**PRAIRIE ISLAND NUCLEAR GENERATING PLANT**  
Docket Nos. 50-282 License Nos. DPR-42  
50-306 DPR-60

**Response to NRC Questions Dated February 12, 2001**

### Prairie Island Response to NRC Follow-up Questions dated February 12, 2001 from the February 9, 2001 Meeting Regarding Unit 1 Steam Generator Eddy Current Test Results

**Figure 1**  
 Structural Limit<sup>3</sup>, EOC Allowable Limit and Physical Repair Limit Curves  
 for Axial PWSCC in Low Row U-bends

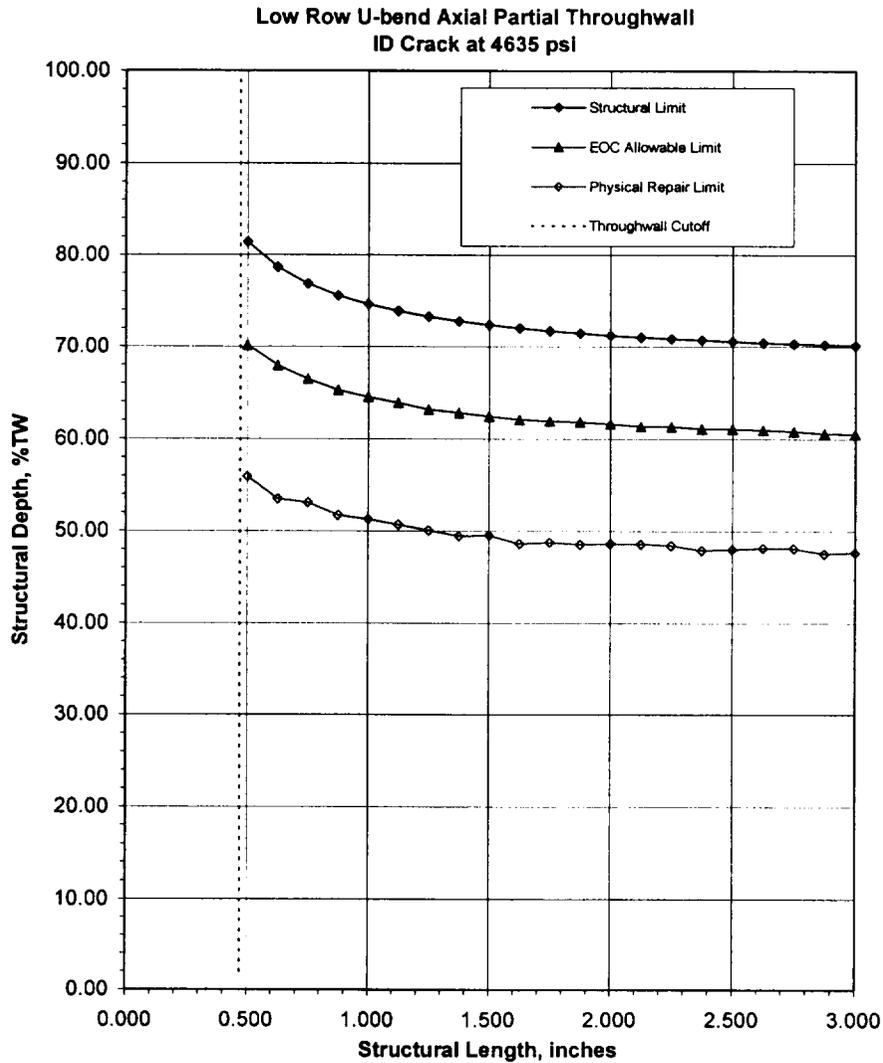
*In the February 10 (sic), 2001 meeting, you presented two approaches to support a conclusion regarding minimum structurally significant flaws in terms of voltage. Provide an explanation of these approaches, the source and applicability of the data, the burst model(s) used, analyses performed, supporting assumptions, conclusions, and how you arrived at your conclusions.*

*Describe the performance demonstration program used to estimate the flaw sizing accuracy used in the U-bend structural analysis. This should include the number and type of tube and flaw specimens and the applicability of the data set to plant-specific conditions (e.g., geometry, flaw signal characteristics, and signal-to-noise ratios), and*

**1<sup>st</sup> Approach: Standard Approach (evaluate all combinations of length and average depth)**

Figure 1 shows a plot of the structural depth versus structural length for ID axial cracks leading to a  $3\Delta P$  burst pressure of 4635 psi at 0.95 probability for the best estimate structural limit, the EOC allowable limit and the physical repair limit. The EOC allowable limit includes material property and burst equation uncertainty. The physical repair limit defines the limit of the actual physical dimensions of cracks which must be found to ensure that minimum  $3\Delta P$  strength requirements will be met at the end of the next cycle. The physical repair limit accounts for crack growth over the next cycle of operation. Figure 1 shows that axial ID cracks in U-bends with average depths of about 50% TW must be found by inspection to ensure structural integrity requirements over the next cycle of operation. Historically, Prairie Island has detected indications meeting the physical repair limits of Figure 1.

The burst equation used in Figure 1 is taken from the EPRI Flaw Handbook (in final publication), Section 5.1.4, Part-through-wall Axial Cracking. It is based entirely on

The growth rate distributions used to construct Figure 1 are the same as those used in the Westinghouse/E-Mech CMOA analysis for Indian Point Unit 2 (Figure 5.5).<sup>5</sup> The log normal distribution of average depth crack growth rates has an upper 95<sup>th</sup> percentile growth rate of 12.9%TW/EFPY and a median value of 3.45 %TW/EFPY. The length growth rate distribution meets or exceeds that used in the Indian Point 2 CMOA.

**Figure 4**  
 Estimated Lower Bound Burst Pressures  
 From IP2 400 kHz NDE Crack Profile Versus Fitted Volts/Length Correlation

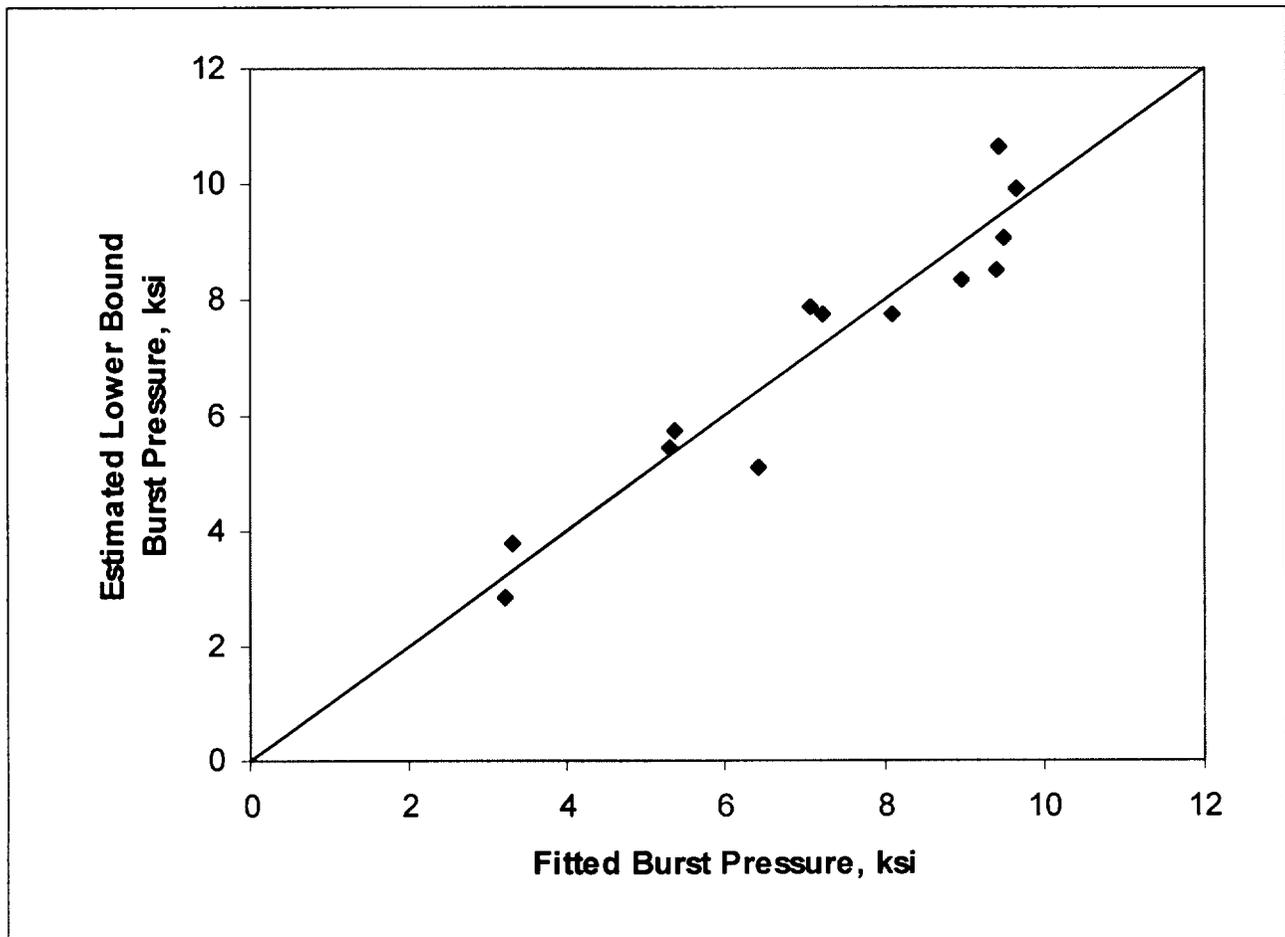
*Provide the data base that supports the burst correlation to voltage and flaw length. Discuss why it is applicable to PINGP.*

The Westinghouse/E-Mech CMOA analysis for Indian Point 2 lists NDE determined axial crack profiles along with average depth and effective length from 400 kHz +Point™ data. See Section 3 and Table 3-5 of the Indian Point 2 report. With these depths and lengths, use of the original Framatome equation provides estimated lower bound burst pressures (*ELBP*). The original Framatome equation is within 1% of the lower 95<sup>th</sup> tolerance interval of pulled tube burst pressures where actual profiles are known from destructive examinations. Correlation of estimated lower bound burst pressure in psi with measured +Point™ voltages, *V*, (peak to peak at 400 kHz) and +Point™ lengths, *L*, from the Indian Point 2 data yields the equation:

$$ELBP = 11340 - 1593 \cdot V - 1837 \cdot L$$

Figure 4 shows a plot of *ELBP* versus the fitted values from the above equation. The 13 point fit is excellent. The standard error of estimate about the regression line is 759 psi.

**Figure 8**  
SG 11 Noise Levels – Mid Range Frequency

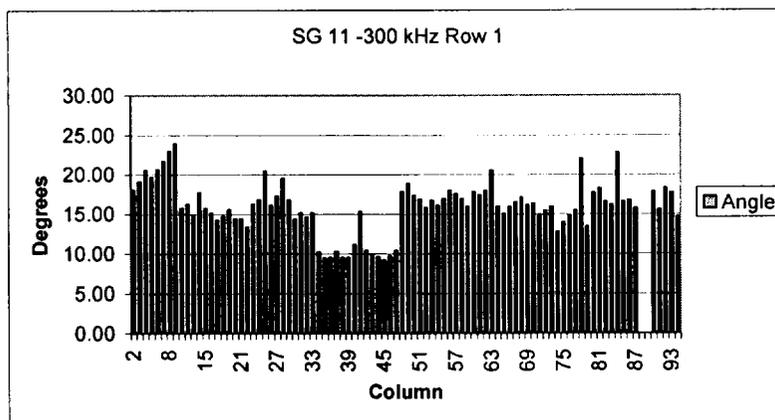
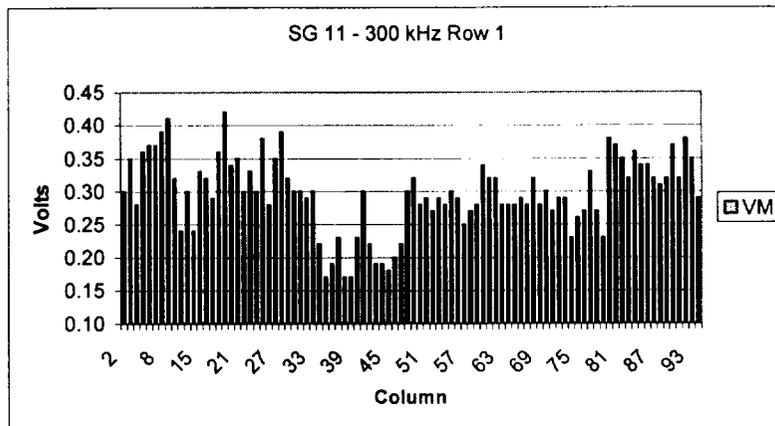
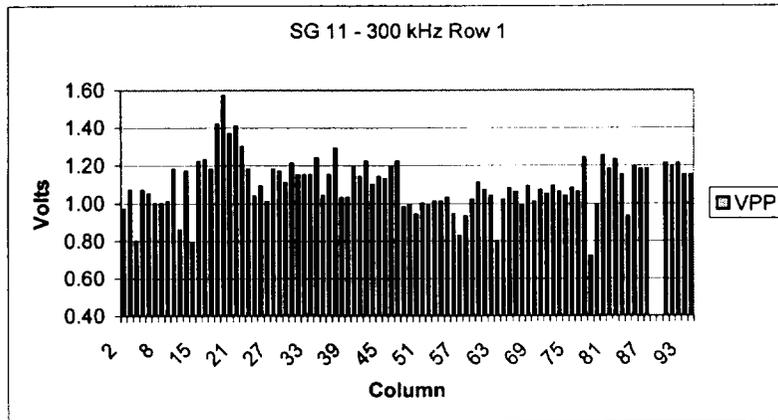
*Discuss the criteria for reinspection and rejection of tubes, the basis for this criteria, and the outcome of all reinspections (e.g., changes in measured parameters).*

*Discuss and provide the basis for your minimum reliable detection capabilities in terms of tube-by-tube factors such as signal-to-noise ratios and noise parameters, including volts peak-to-peak and vertical maximum. Include this information for tubes inspected with the midrange as well as for tubes inspected with both the midrange and high frequency probes.*

11 SG contained the noisiest rows 1 and 2 U-bends. Figure 8 illustrates the noise levels in 11 SG row 1 U-bends. Those tubes exceeding the above noise criteria were retested with the high frequency probe. Figure 9 shows a decrease in the peak to peak noise levels. Also, Figures 8 and 9 include a plot of the phase angle calculated from the peak to peak volts and the vertical maximum volts for each tube.

Using the noise acceptance criteria from Table 4, a box can be postulated that limits maximum noise levels allowed. For the 300 kHz frequency, the noise box is a rectangle with a vertical height of 0.4 volts and a horizontal value of 1.09 volts.

**Figure 14**  
 Prairie Island Dents per Inspection Year, Grouped by TSP Location

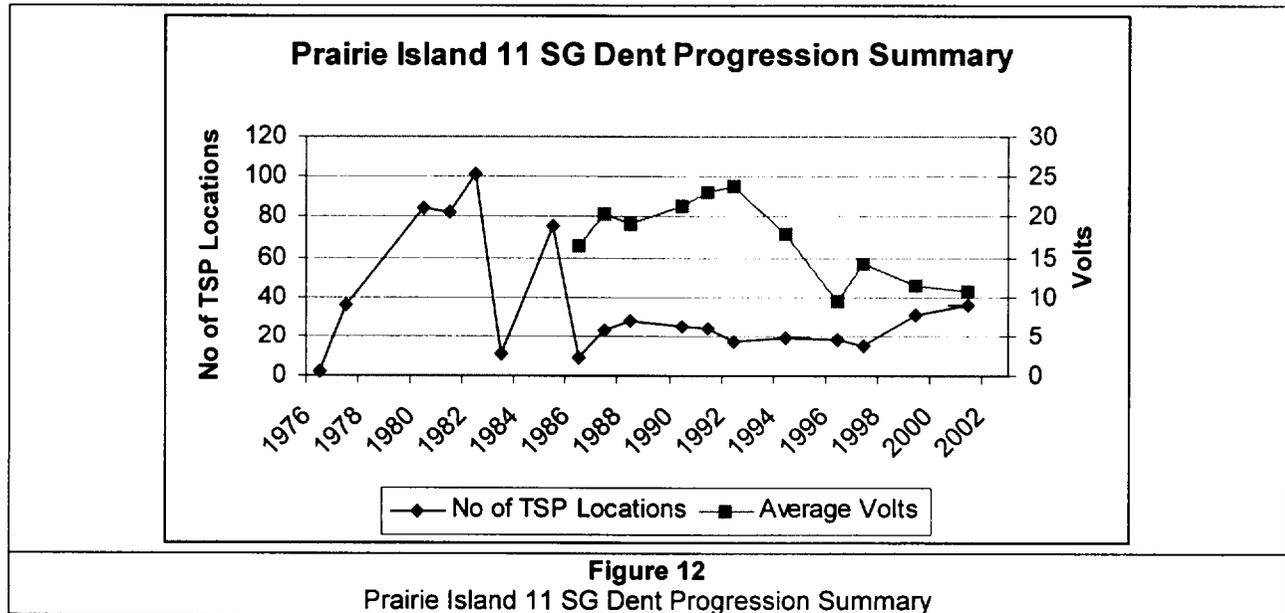
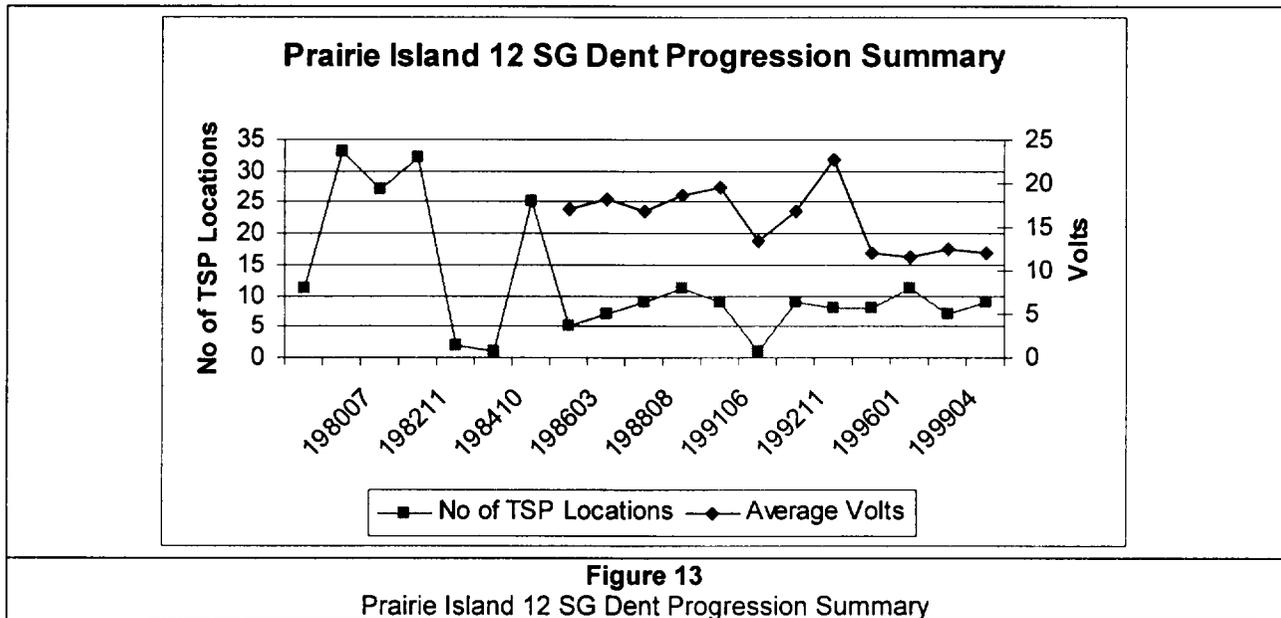
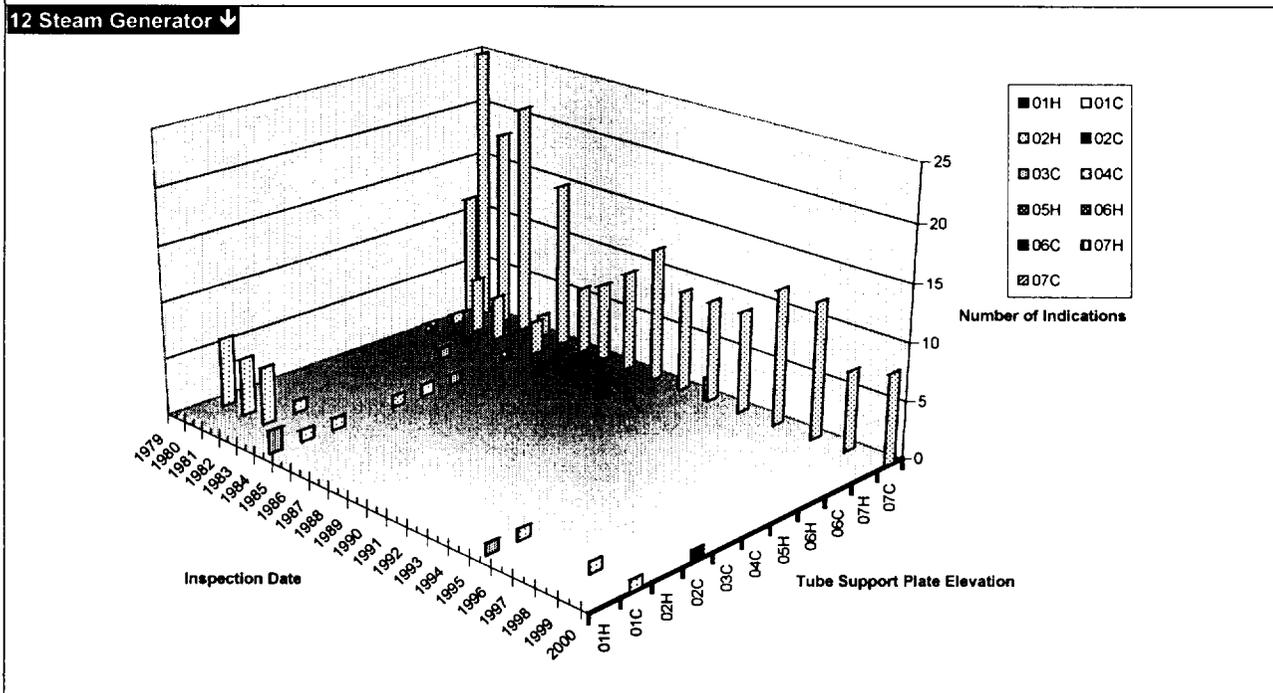
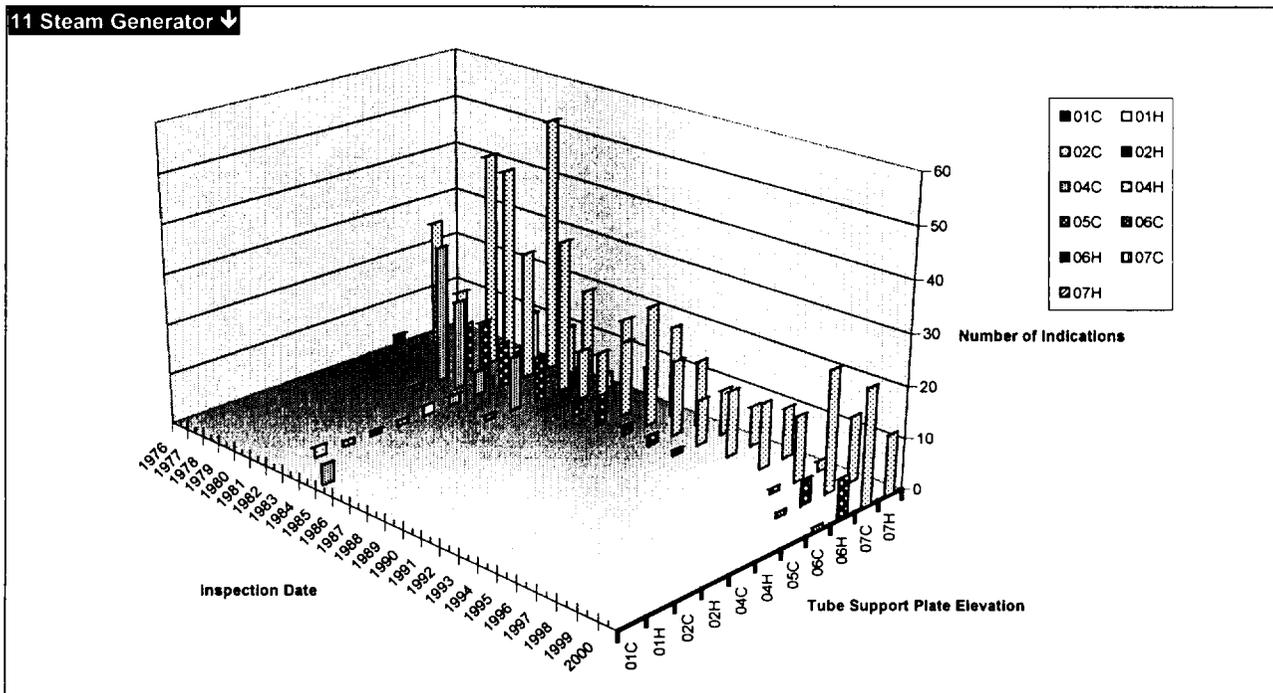
*Provide a summary of the location and magnitude of tube dents that are in the PINGP, Unit 1, steam generators. Discuss how the number and size of these dents has changed over time.*

*Discuss the PINGP experience with dents or U-bend restrictions of eddy current probes. Provide in this context your definition of a dent.*

Progression of Dents in 11 and 12 steam generators (as measured by the number of dent locations and the average voltage of all the dents each refueling inspection) is displayed in Figures 12 and 13. Dented condition is recorded when channel P1 is greater than or equal to 5.0 volts.

Figure 14 shows the trend of the number of dents at each tube support plate elevation, separately for cold leg and hot leg. No dents have been found lower than the 6th tube support plate since 1986. In the 2001 inspection, one of the dents is in row 6, the other nine are in the outer periphery beyond row 40 .

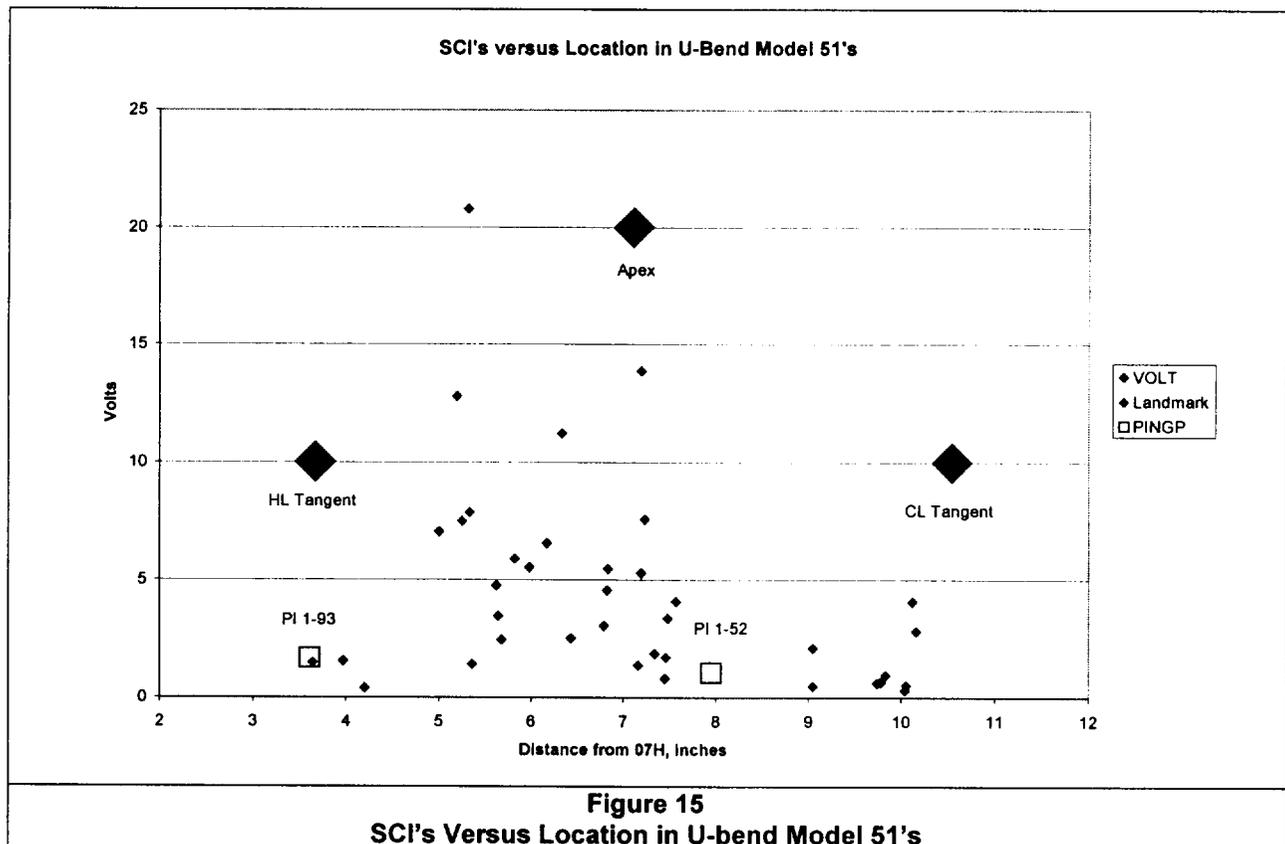
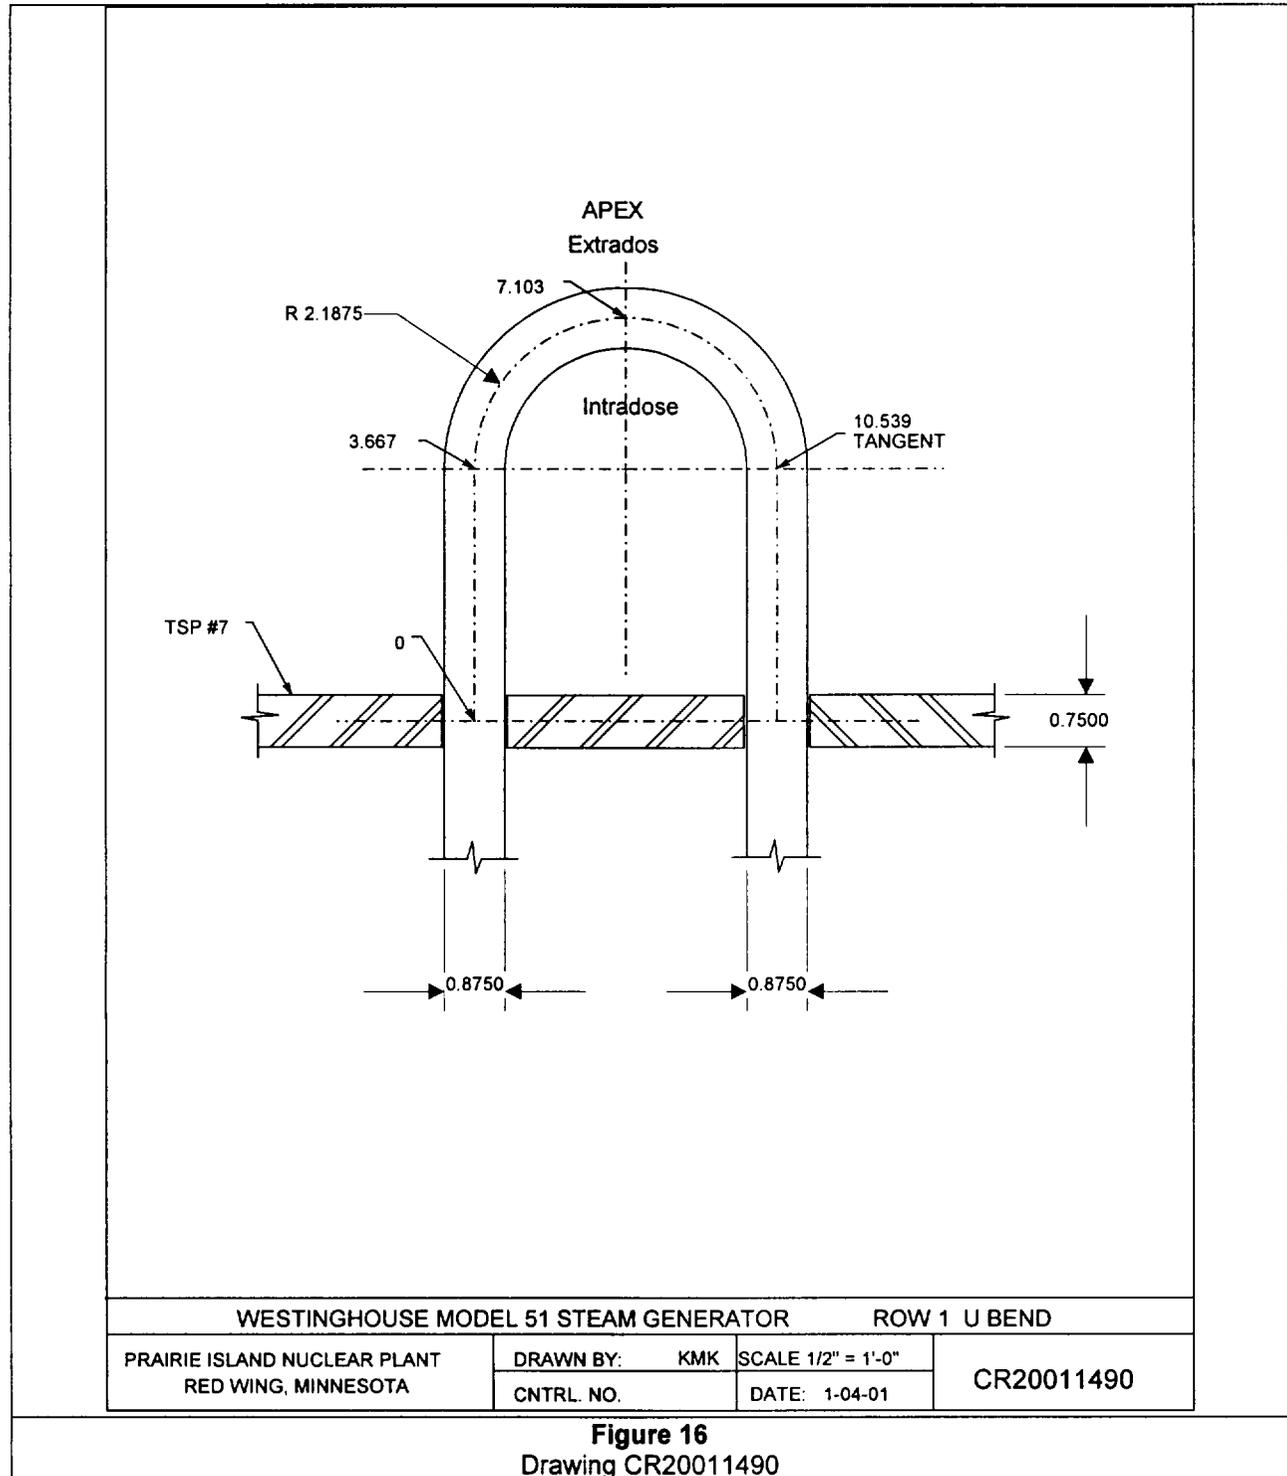
*Provide a complete description of the location in the steam generators of the U-bend circumferential indications found in the February 2001 outage at PINGP.*

Refer to Figure 16. The location of the circumferential indications (07H+~7.8 inches) is on the intradose of the U-bend about 0.7 inches from the apex on the cold leg side.

As seen Figure 15, it is not unusual to see circumferential indications scattered about in the U-bend region, some of which are on the intradose.
